| Project | 8 PILGRIMS LANE NW3 1SL- 2012/5825/P - APPEAL | Project Ref | G1206 |
| Subject | On Grieg Ling 05/02/14 Additional Basement Information and Footing–Undrained–Plaxis Report. | Date | 11/2014 |

EXISTING SECTION AT TP1

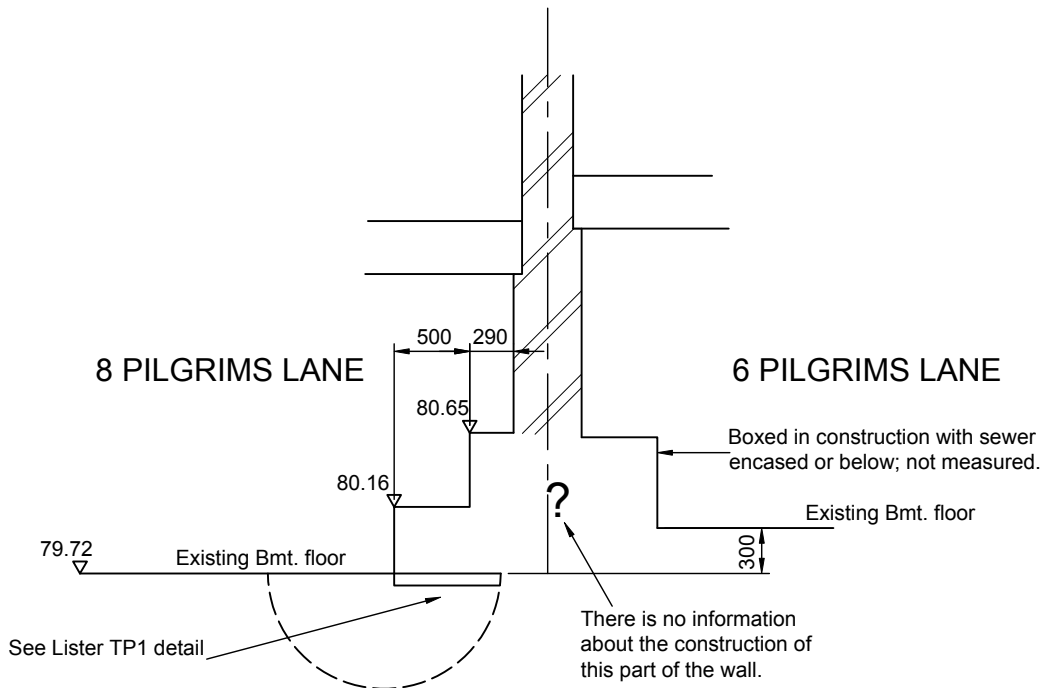
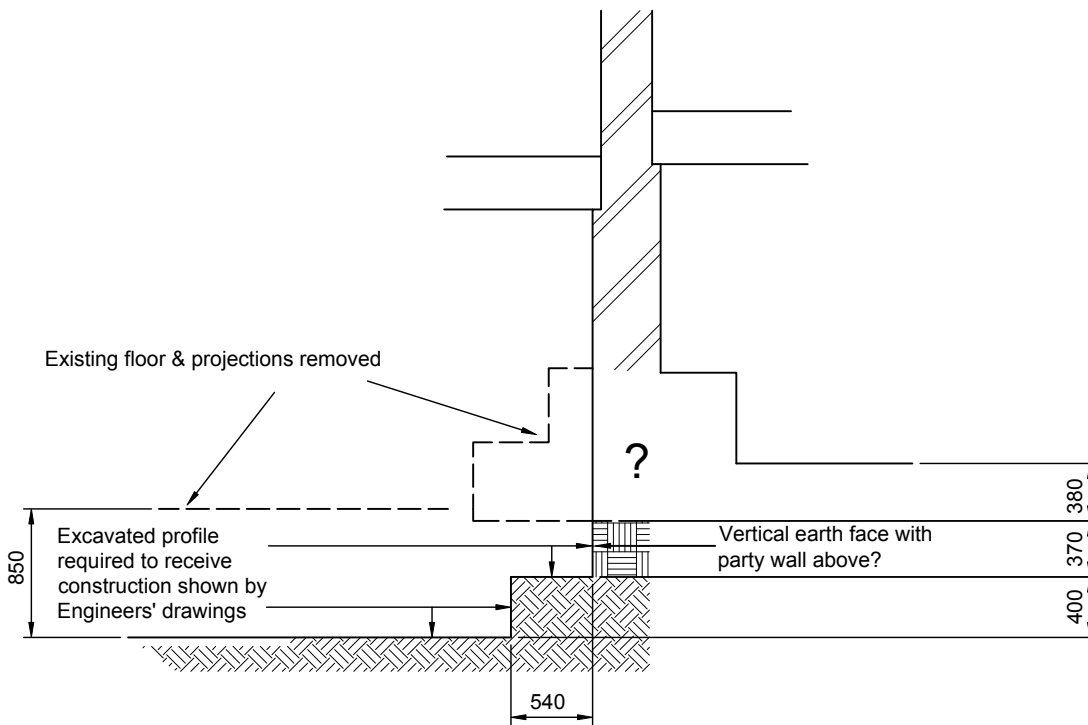
Attached sketch G1206-SK-01-E1 shows (a) the information about the existing construction that has and has not been found by the appellant and (b), how constructing the front basement according to the Architects’ and Grieg Ling drawings will affect what must currently be supposed to exist. The sketch is the best interpretation of the developer’s intention which is possible at the present time.

Note that the application drawings design a situation which would be dangerous.

The ground under the party wall would be unstable and the party wall would slide into No 8 basement excavation. This was the conclusion of paragraph 84 of my December 2012 report. The warning has been ignored.

This sketch collates information from the Lister ground investigation report and Architects' and Engineers' drawings. The designers do not know how the base of the wall is constructed, do not propose to underpin the existing party wall and show no means of restraining the vertical earth face.

The RKD "Plaxis" analysis presented by the Engineers purports to show that the situation is satisfactory and that there is no risk of significant damage to No 6.

Figure 1

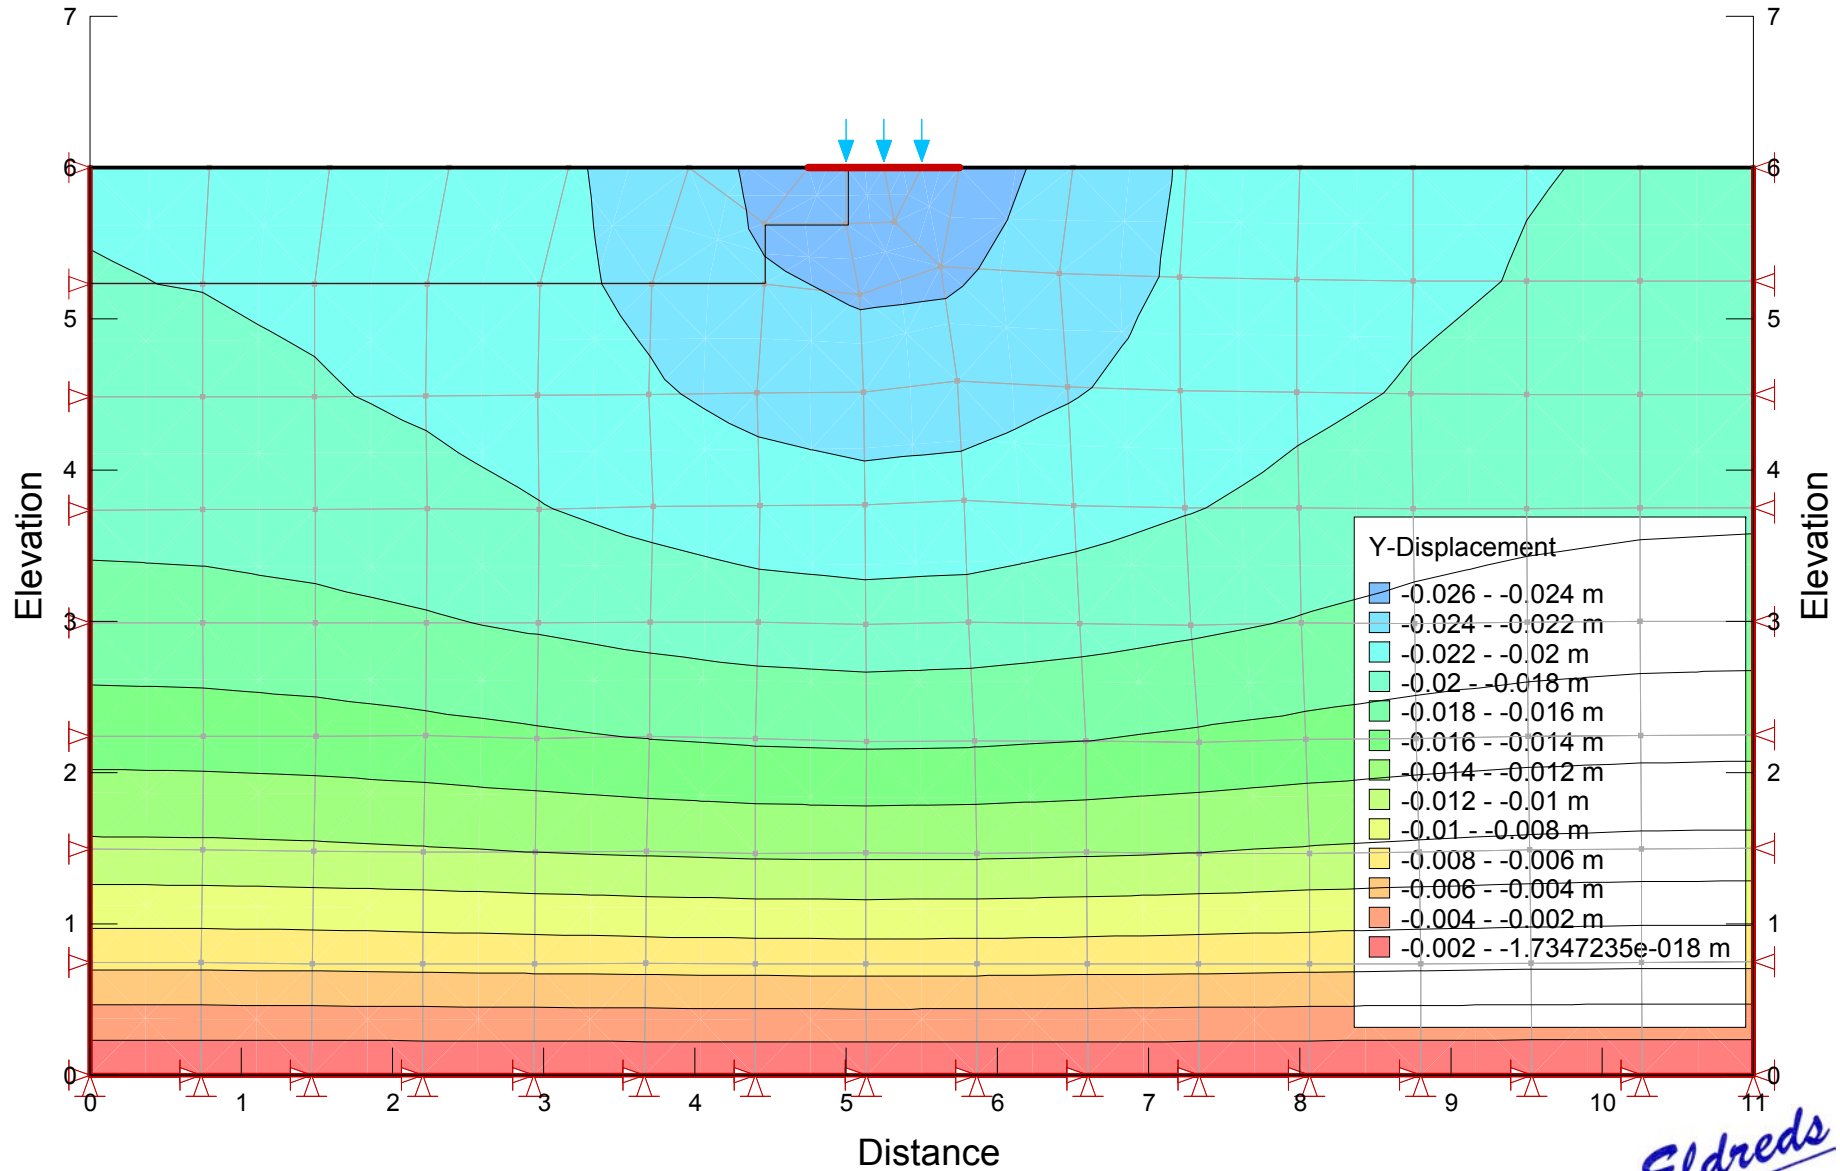
Figure 1 estimates the deformation caused by the party wall footing. The building has been there for more than a hundred years and the analysis allows for that.

Figure 2

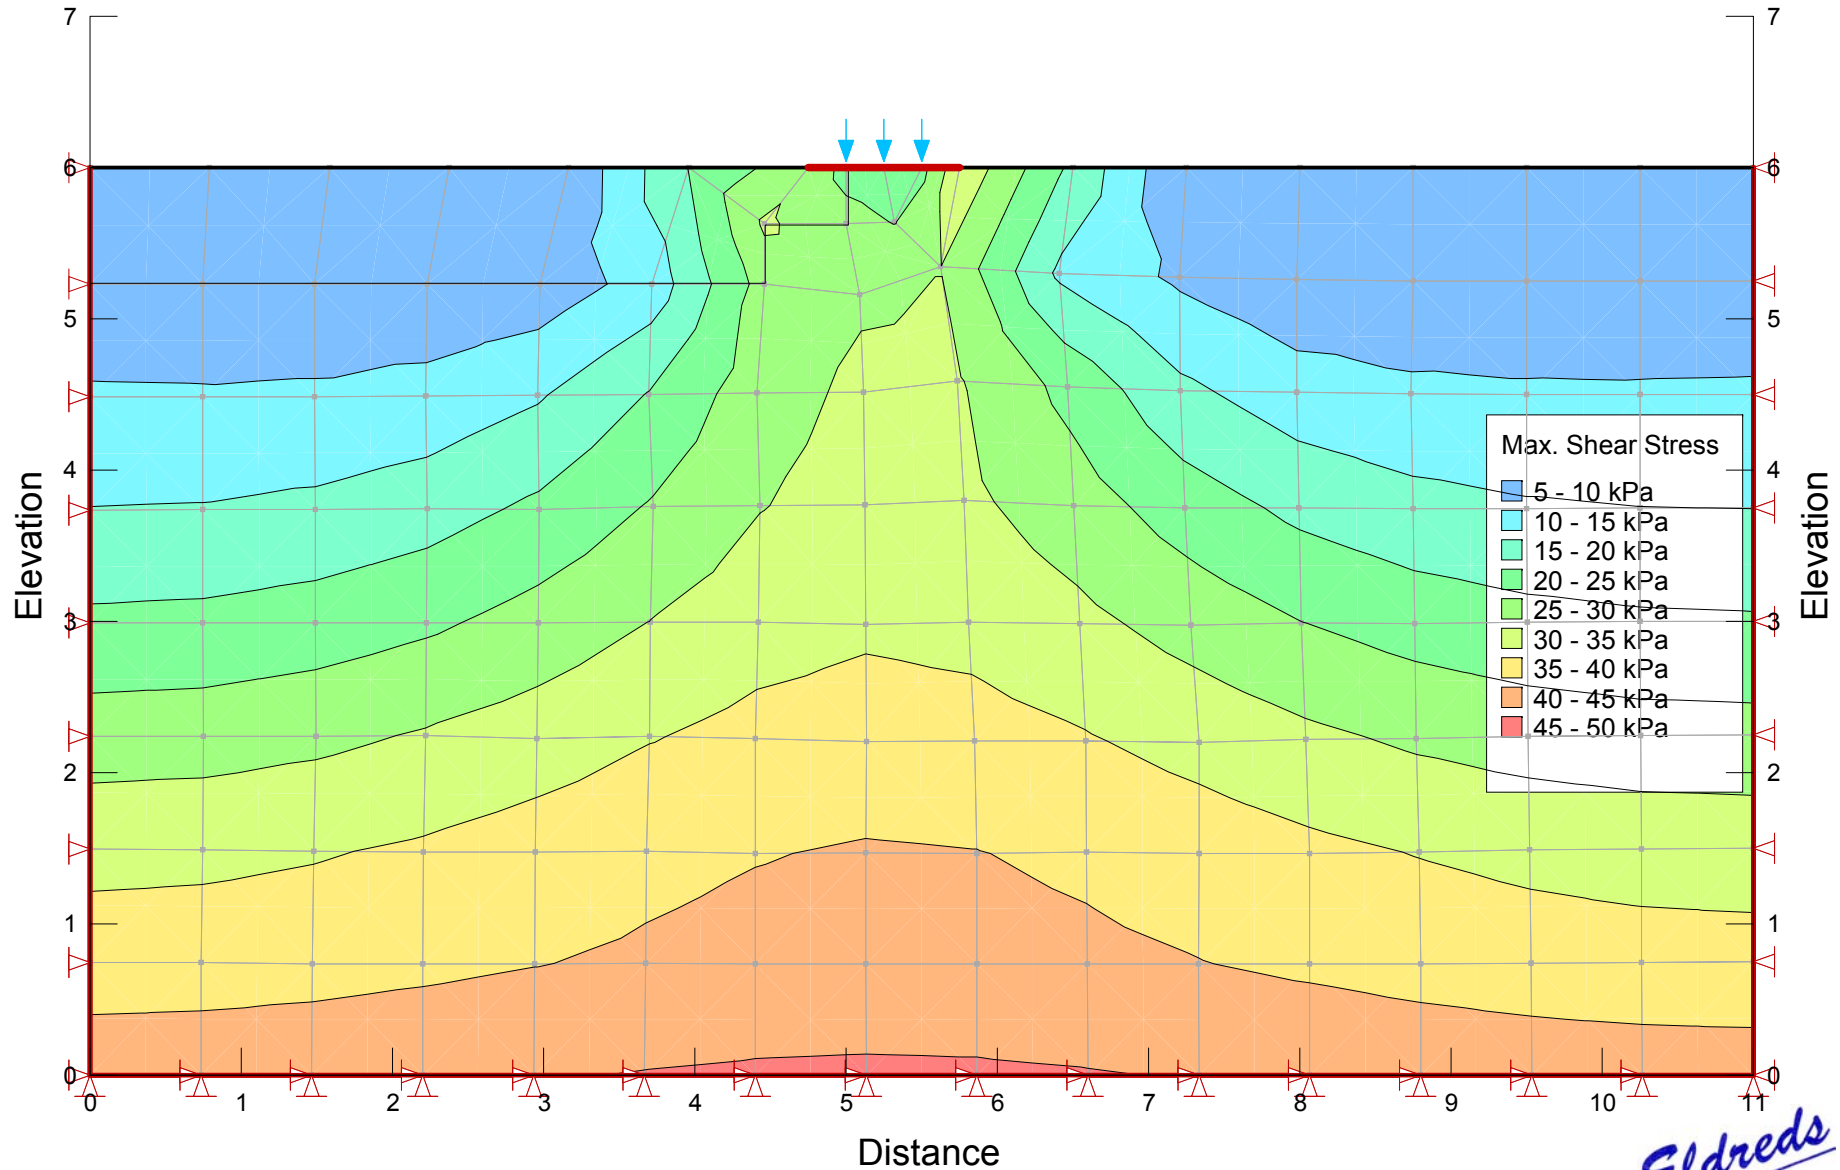
Figure 2 shows the shear stresses caused by the deformation.

Figure 3

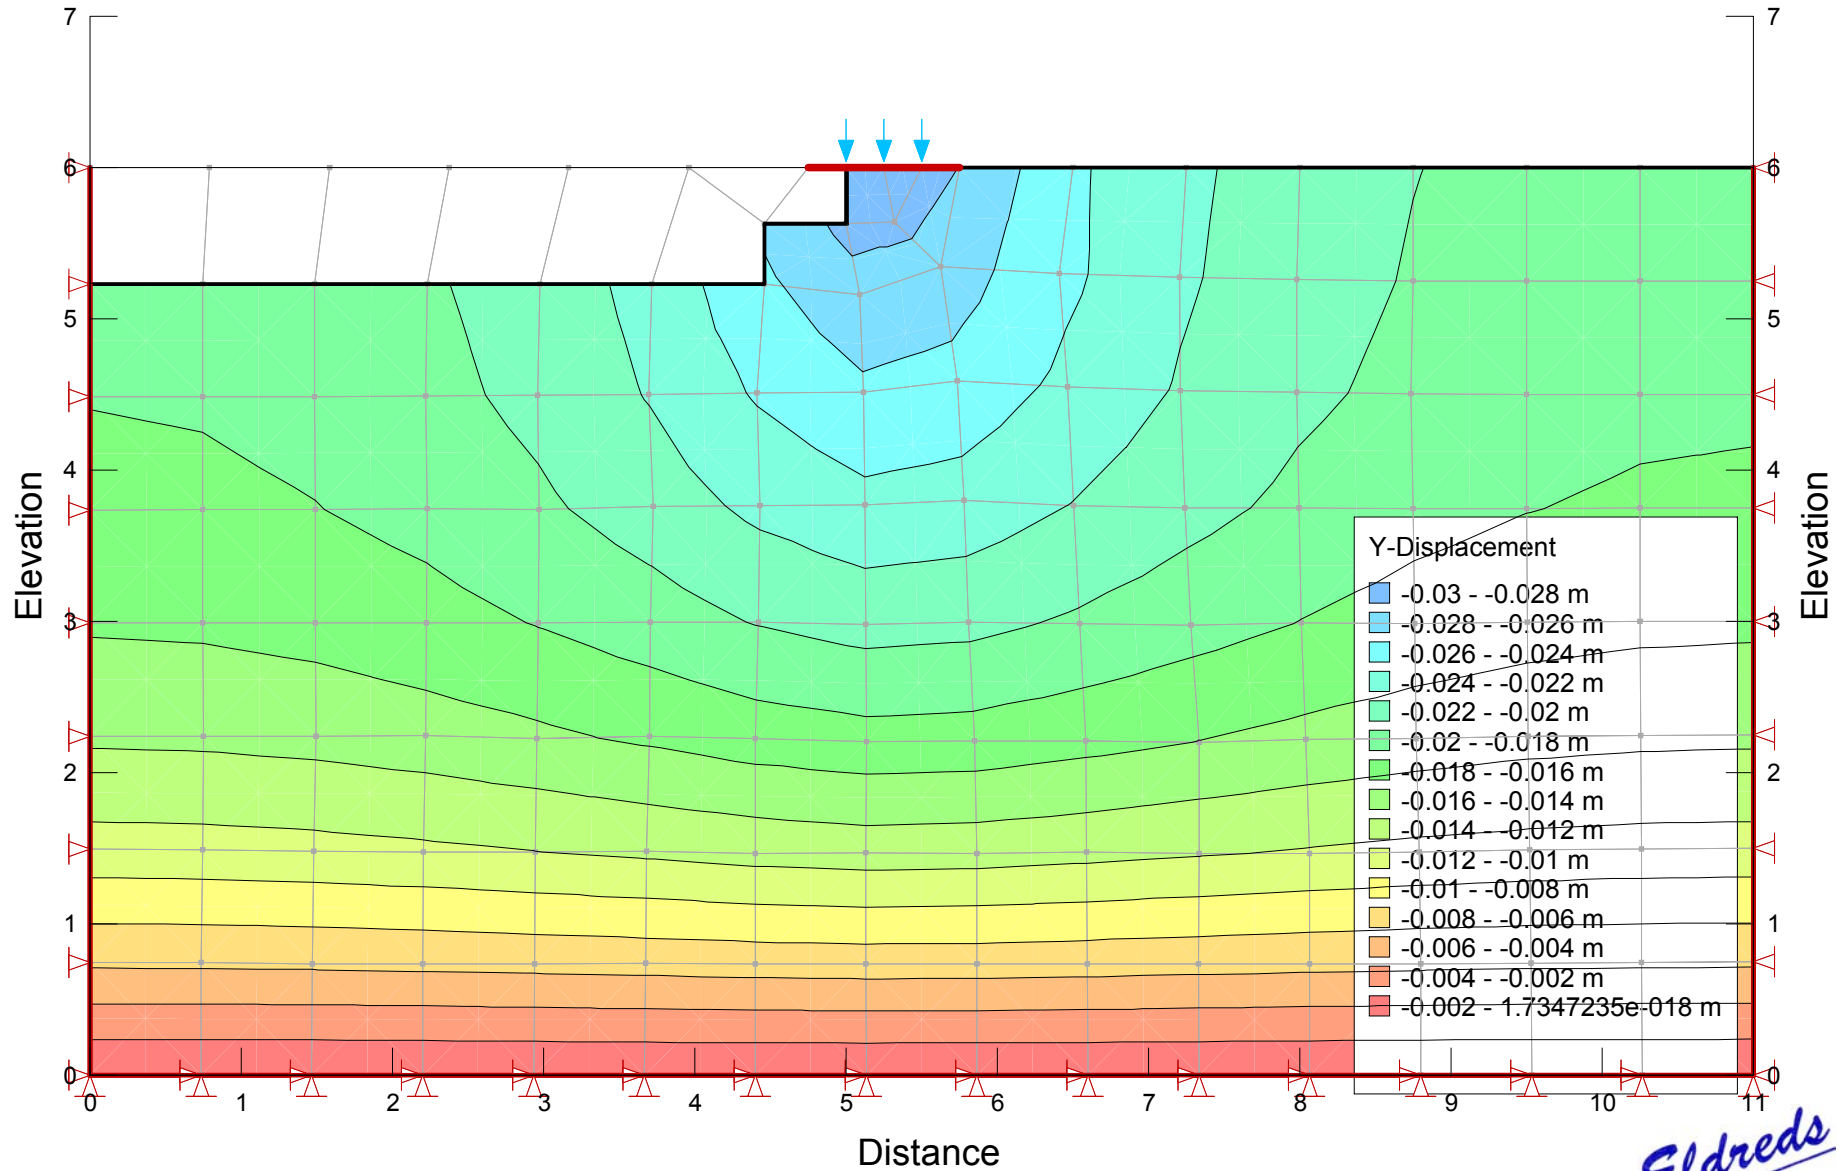
Figure 3 estimates the immediate deformation that would result from the excavation.

Figure 4

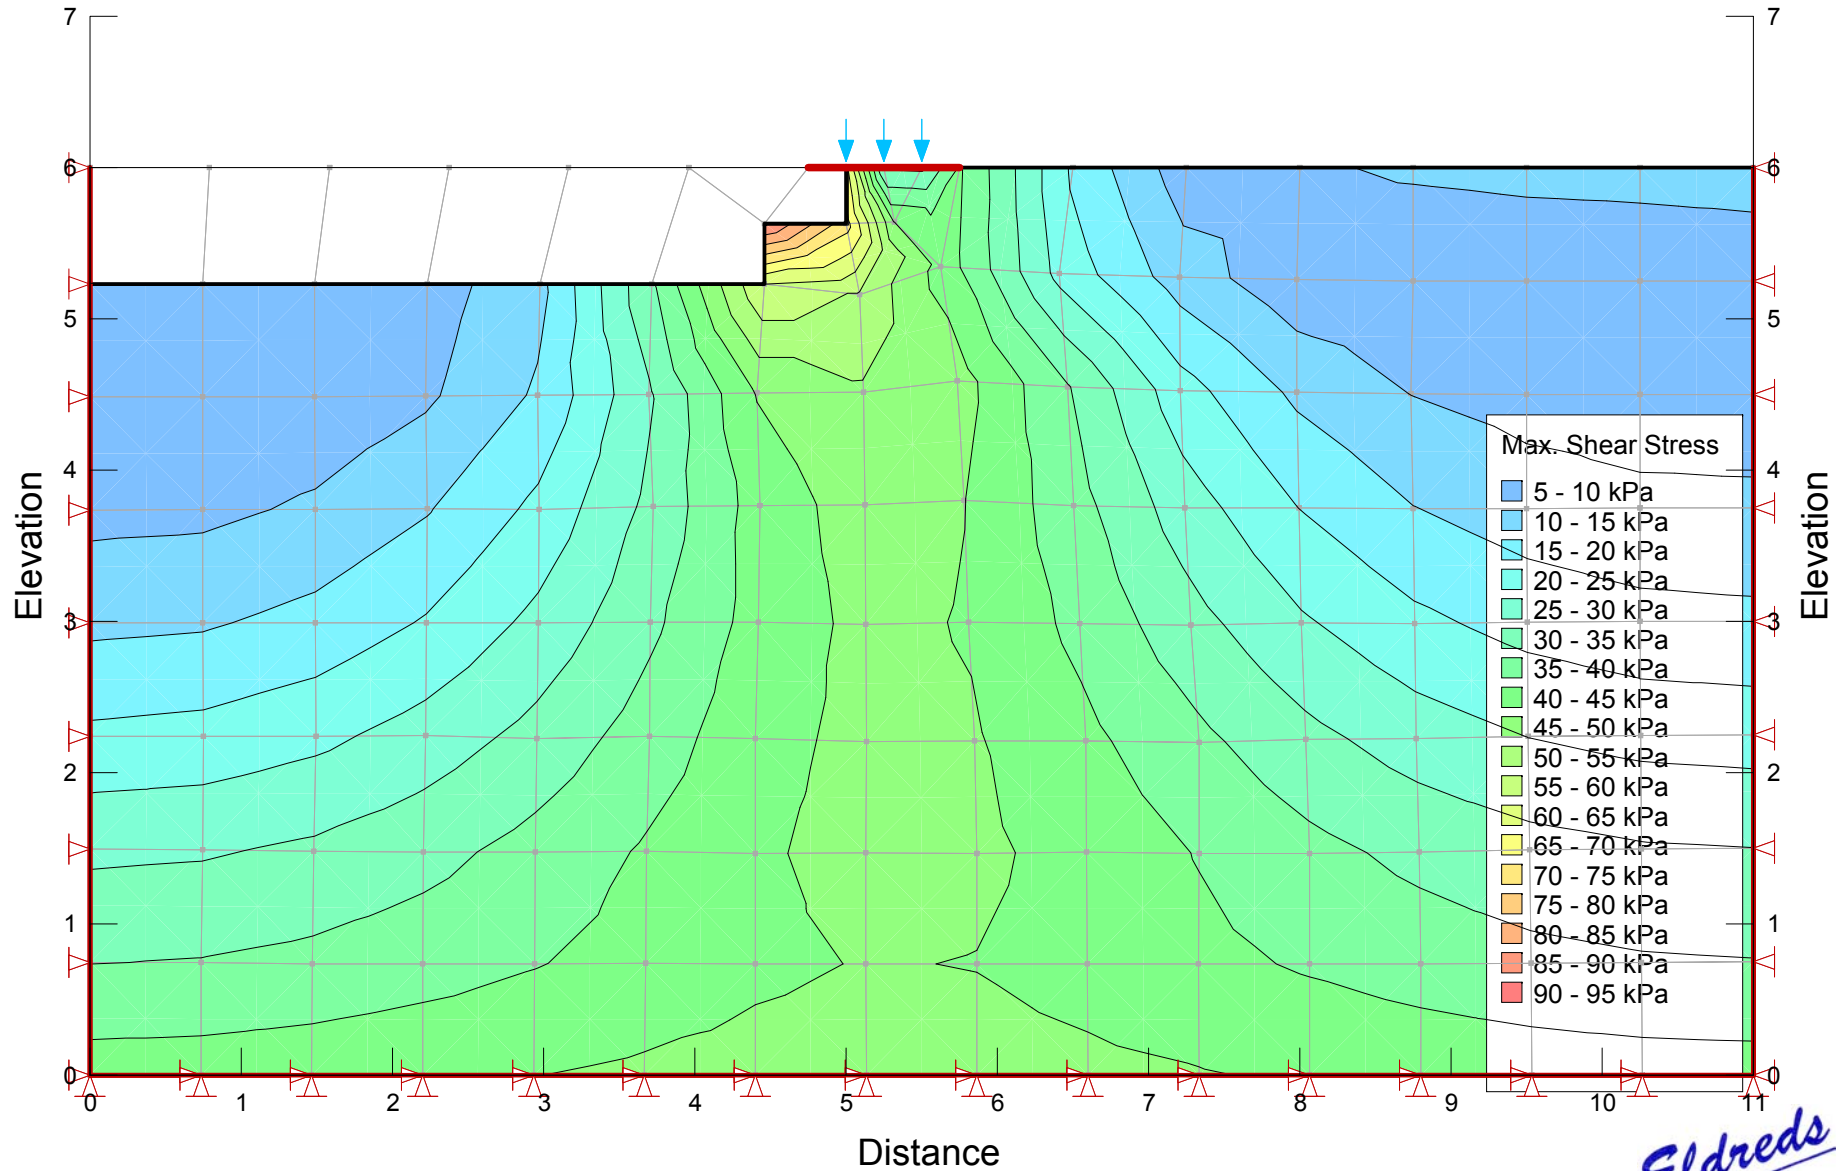
Figure 4 shows the shear stresses that would result from the change.

The results attached also estimate that movement due to the excavation would be very small. But they also show that the shear stresses caused would be much greater than the ground strength.
